## COUNCIL AGENDA REPORT

SUBJECT: CONSIDER AN APPEAL OF A PLANNING COMMISSIONER DECISION DENYING A REQUEST TO CONSTRUCT AN ADDITION THAT EXCEEDS THE ALLOWABLE FLOOR AREA RATIO ON PROPERTY ZONED R-1:8. APN 523-12-039. ARCHITECTURE AND SITE APPLICATION S-02-33  
PROPERTY LOCATION: **980 CHERYSTONE DRIVE** PROPERTY OWNER/APPELLANT: JOAN HINKIN

REPORT TO: The Planning Commission  
FROM: The Director of Community Development  
LOCATION: 980 Cherrystone Drive  
Architecture and Site Application S-02-33

RE: 980 Cherrystone Drive

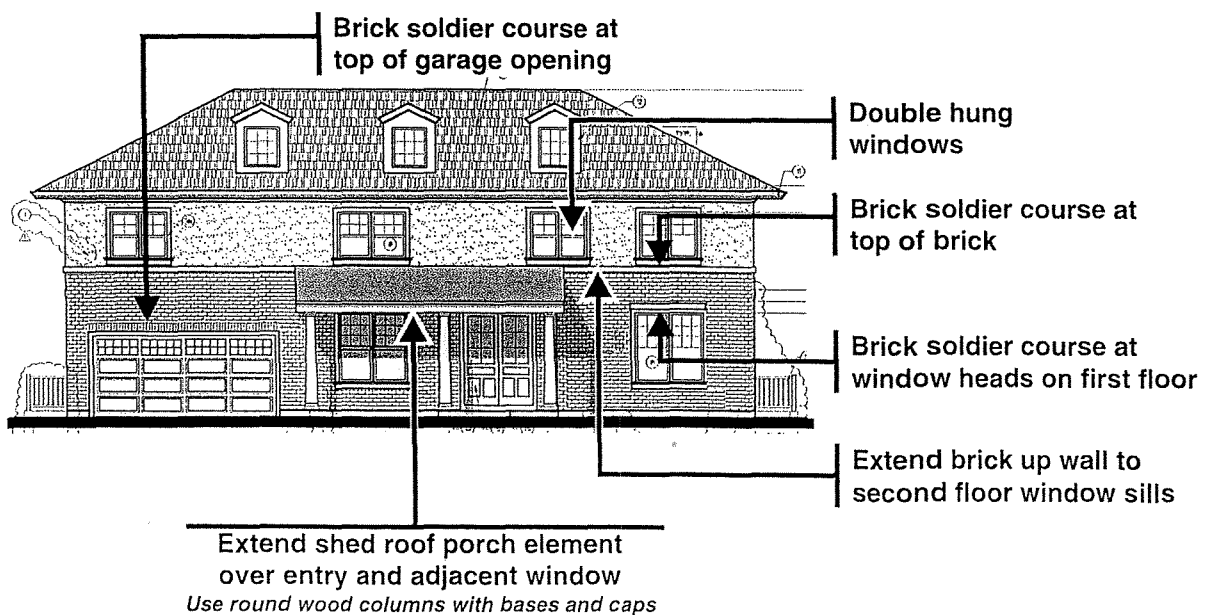
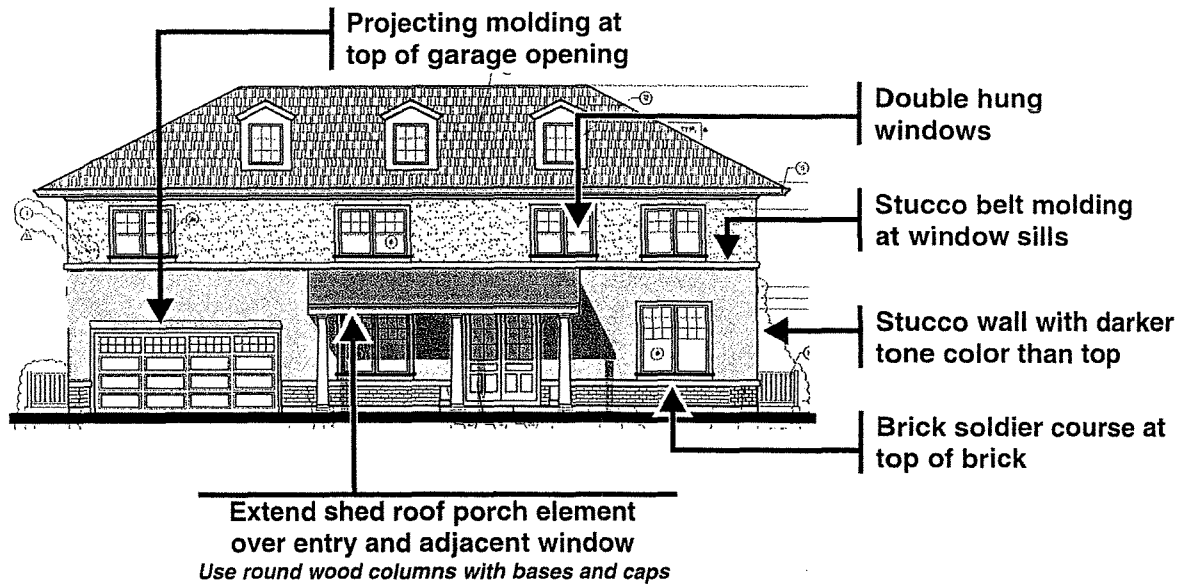
1. The primary concern with this proposal is its blocky, two story massing and design formality which is out of keeping with the immediate neighborhood.

2. The entry with formal columns and entablature are actually very close to the surface of the front wall as shown on the entry plan to the right, and does not assist in mitigating the large two story mass of the structure as viewed from the street.

3. The drawings are a bit confusing regarding the exterior wall materials. The overall approach as to where to use brick for lower wall portions, brick for full height walls, and stucco is unclear to me.

4. It appears that the intent is to use double hung windows, but the drawings are not clear in this regard. This is probably just a function of the drawing symbol used for the windows which does not show solid rail where the upper and lower window sections meet.

5. I noted the intent to use a molding at the juncture of the wall and roof soffit. This is a good detail, and should be retained.

1. Add a projecting porch with wood columns across the entry and adjacent window. This would break up the two story wall, add some depth to the facade, and reflect the break up of two story walls in the immediate neighborhood.
2. Extend the brick on the lower wall surface up to the second floor window sills.
3. Carry the brick around all four sides of the house at this consistent level.
4. Use brick soldier courses at the top of first floor window heads and at the projecting belt course at the top of the brick.
5. Use double hung windows with interior dividers between the small window panes that have some visual depth (i.e., no snap in grids.)
